Bayside Planning Panel

Item No	6.6
Application Type	Development Application
Application Number	DA-2017/307
Lodgement Date	23 March 2017
Property	28 Alfred Street, Ramsgate Beach
Owner	Ramsgate Beach Pty Ltd
Applicant	Space 0.618:1
Proposal	Construction of a two (2) storey attached dual occupancy development, including rooftop terrace, front fence, demolition of existing structures and Torrens title subdivision creating two lots
No. of Submissions	Three (3) submissions
Cost of Development	\$ 625,000.00
Report by	Adam Iskander, Development Assessment Planner

Planning Assessment Report

Application Number:	DA-2017/307
Date of Receipt:	23 March 2017
Property:	28 Alfred Street, RAMSGATE BEACH (Lot X DP 390114)
Owner:	Ramsgate Beach Pty Ltd
Applicant:	Space 0.618:1
Proposal:	Construction of a two (2) storey attached dual occupancy development, including rooftop terrace, front fence, demolition of existing structures and Torrens title subdivision creating two lots
Recommendation:	Approved
No. of submissions:	Three (3)
Author:	Adam Iskander
Date of Report:	13 February 2018

bda BUILDING DESIGNERS AUSTRALIA
P O BOX 11111 MELB VIC 3000

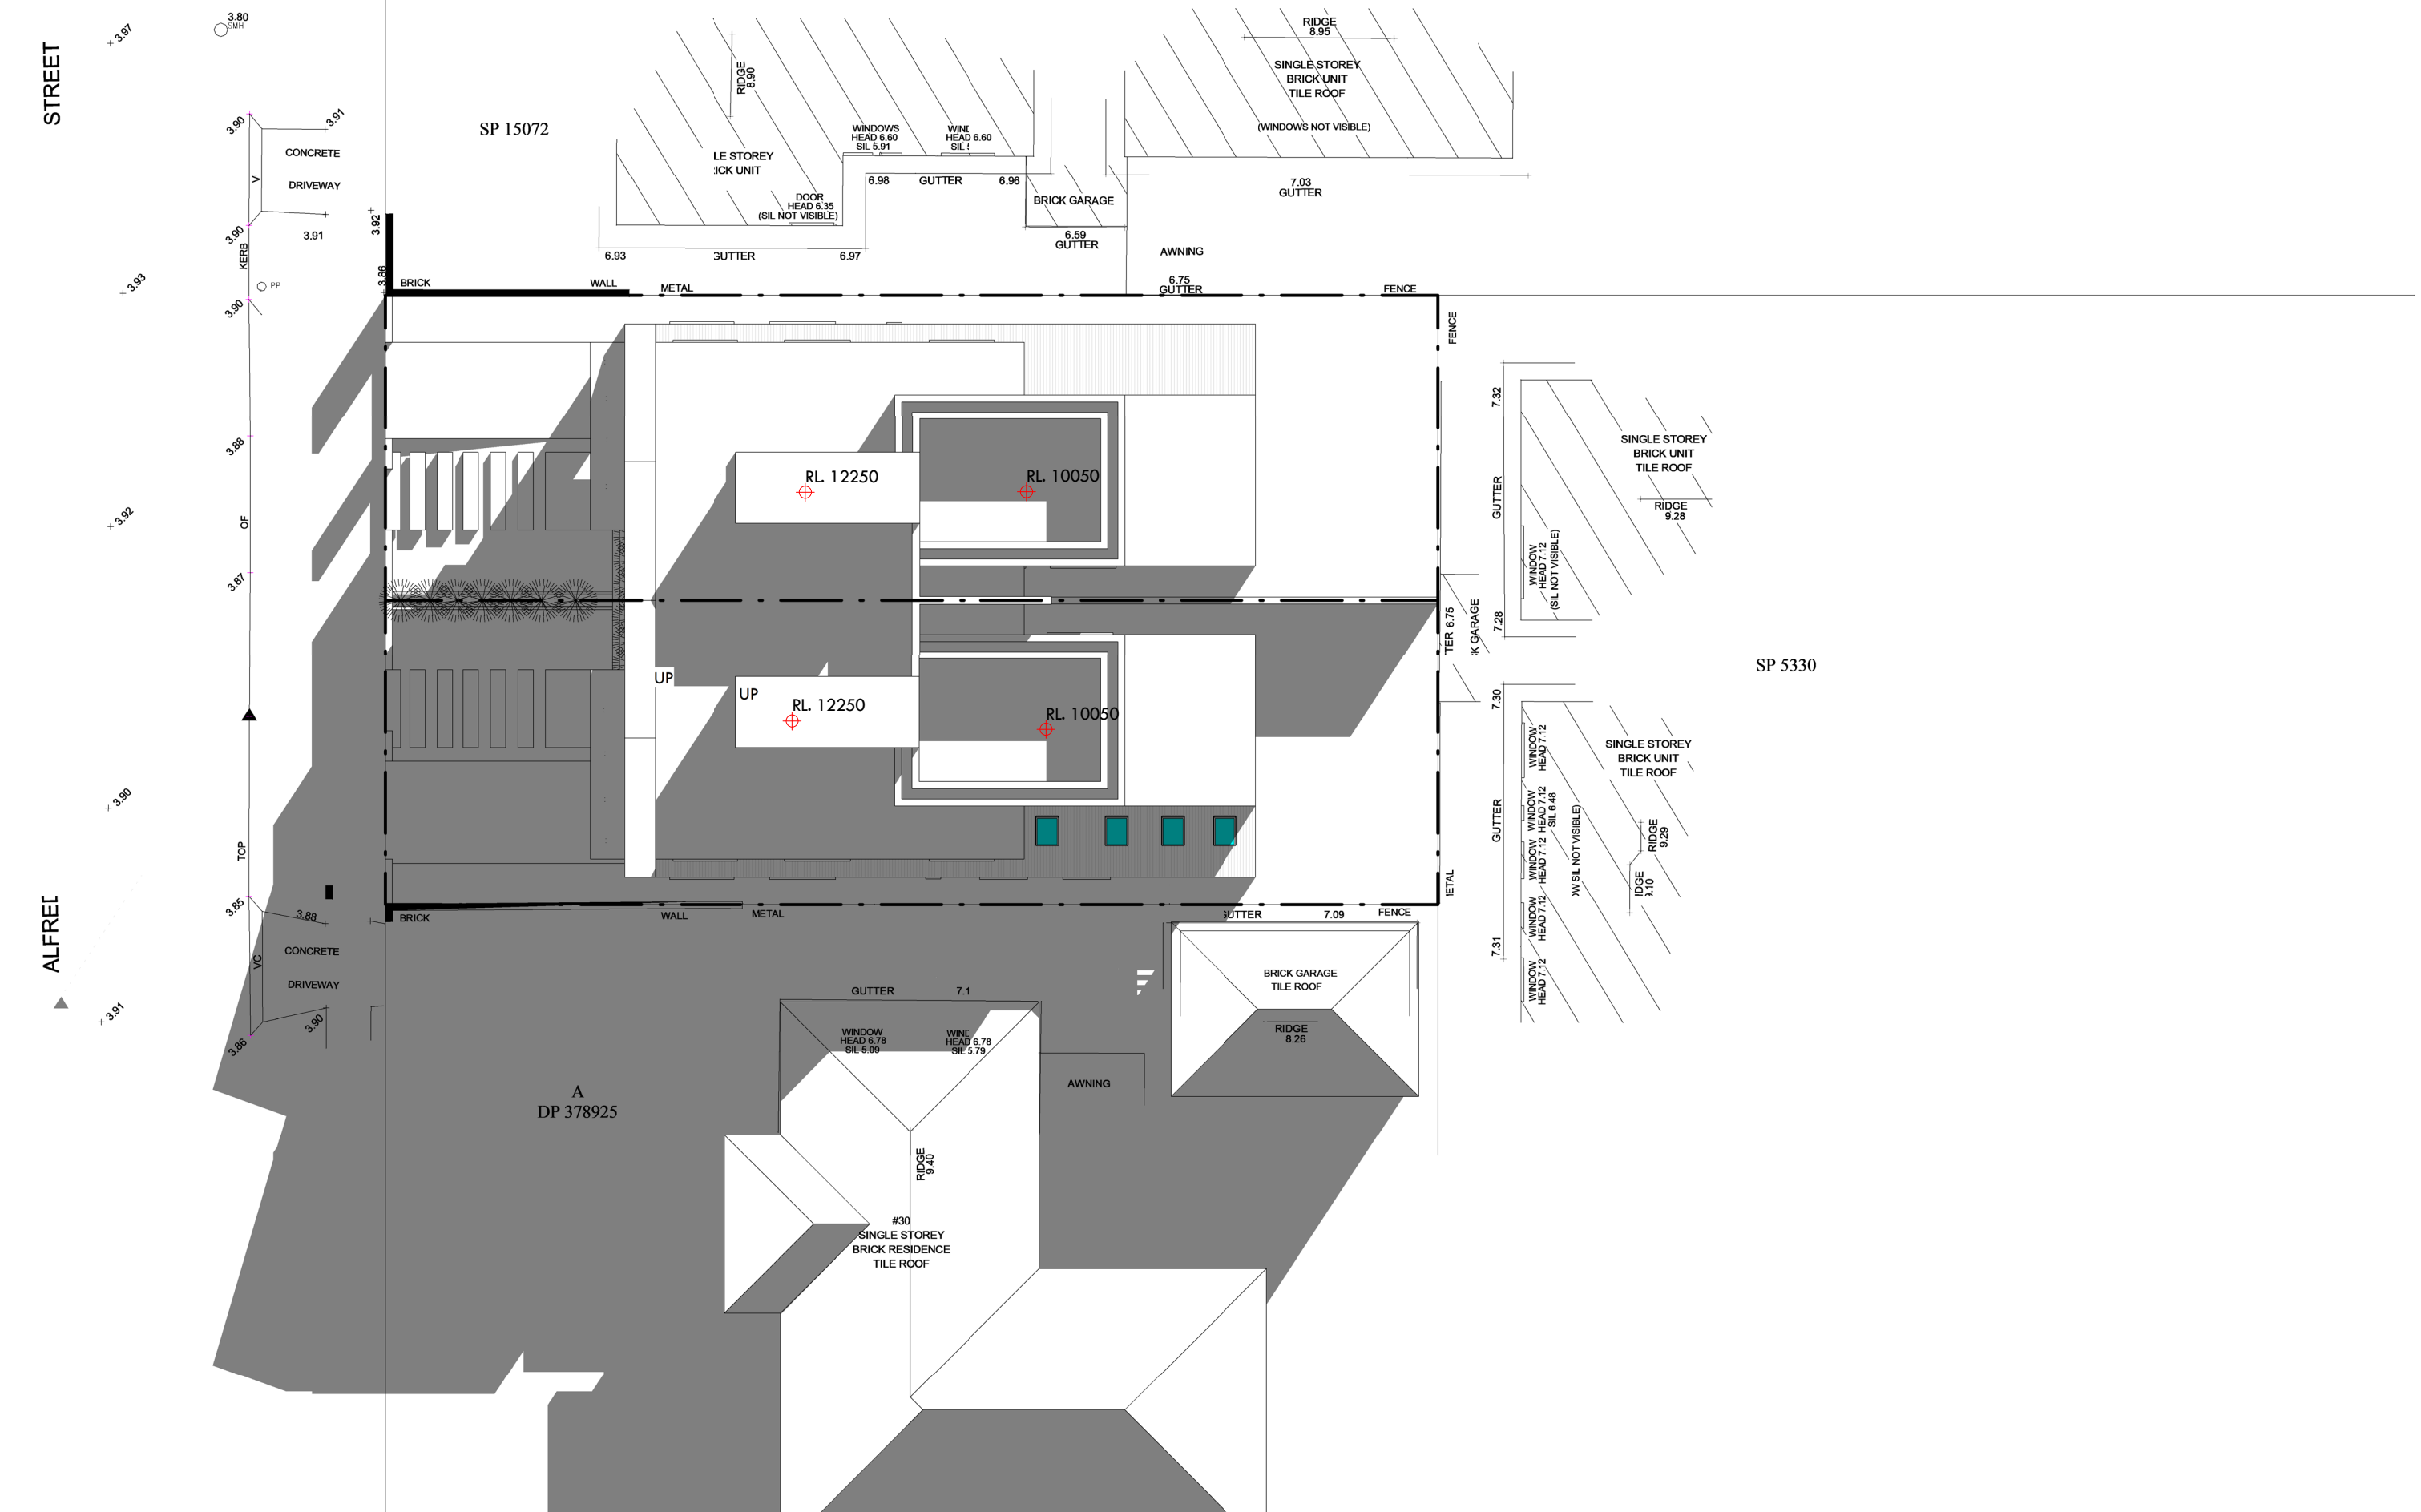
The adjoining dwelling to the south is situated on a property that has an east-west orientation. The applicant has submitted shadow diagrams for 9 a.m., 12 p.m. and 3 p.m. on June 21. The shadow diagrams show that the adjoining windows will not receive the prescribed amount of sunlight, however at least 50% of the private open space will receive sunlight.

The 3D scale shadow diagrams show that at 9am entire yard and rear windows of the adjoining southern neighbour will receive solar access and the front facing windows of the dwelling will receive solar access at 3pm.

The adjoining dwelling to the south is situated on a property that has an east-west orientation. The applicant has submitted shadow diagrams for 9 a.m., 12 p.m. and 3 p.m. on June 21. The shadow diagrams show that the adjoining windows will not receive the prescribed amount of sunlight, however at least 50% of the private open space will receive sunlight.

The 3D scale shadow diagrams show that at 9am entire yard and rear windows of the adjoining southern neighbour will receive solar access and the front facing windows of the dwelling will receive solar access at 3pm.
